<b>Docket Number:</b>	15-AFC-01
<b>Project Title:</b>	Puente Power Project
<b>TN #:</b>	211252
<b>Document Title:</b>	Sierra Research letter to Ventura County Air Pollution Control District Regarding Response to Sierra Club Concerns
<b>Description:</b>	N/A
<b>Filer:</b>	Paul Kihm
<b>Organization:</b>	Latham & Watkins LLP
<b>Submitter Role:</b>	Applicant Representative
<b>Submission Date:</b>	4/25/2016 4:54:09 PM
<b>Docketed Date:</b>	4/25/2016

Re: Response to Sierra Club Concerns with Use of ADJ\_U\* Option  
Puente Power Project

# Modeling Protocol Review For Mandalay Energy Center

**AAQA Process**

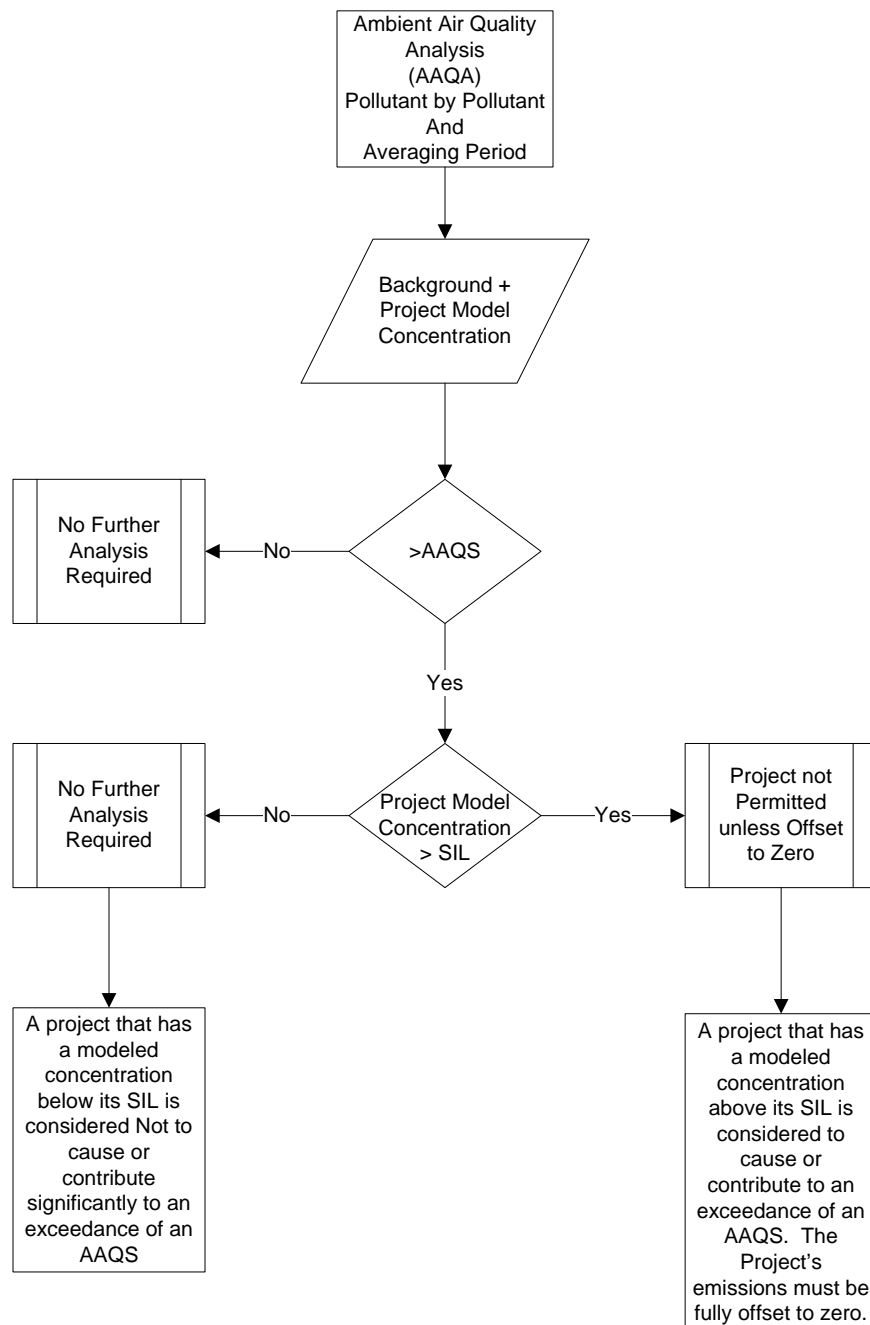
The AAQA analysis proposes using EPA preferred method of model concentration vs. SIL and then modeling plus background, the District recommends reversing steps 1 and 2 (p. 10-11), see flow chart below.
